Well Name: PAN AMERICAN FEDERAL	Well Location: T30N / R14W / SEC 24 / NWNW / 36.805435 / -108.265961	County or Parish/State: SAN JUAN / NM
Well Number: 1E	Type of Well: CONVENTIONAL GAS WELL	Allottee or Tribe Name:
Lease Number: NMSF081231B	Unit or CA Name:	Unit or CA Number:
US Well Number: 300452367500S1	Operator: DUGAN PRODUCTION CORPORATION

Type of Submission: Subsequent Report Type of Action: Plug and Abandonment

Completed P & A Schematic

RE: Revised proposal post CBL

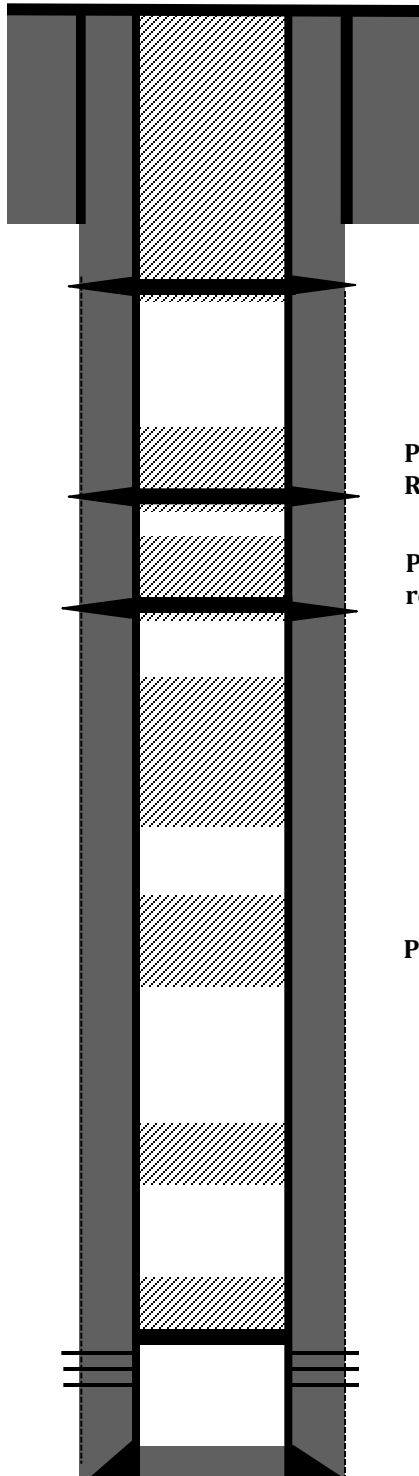
Plug VII, Inside/outside 4 1/2" casing, perforations at 294', Cement Retainer at 256', 121 sks, 139.15 cu ft, Surface Casing-Kirtland-Surface, 0-294'.

Plug VI, Inside/outside 4 1/2" casing, perforations at 1327', Cement Retainer at 1296', 59 sks, 67.85 cu ft, Fruitland, 1064'-1327'.

Plug V, Inside/outside 4 1/2" casing, perforations at 1683', Cement retainer 1642', 59 sks, 67.85 Cu.ft, Pictured Cliffs, 1389'-1683'
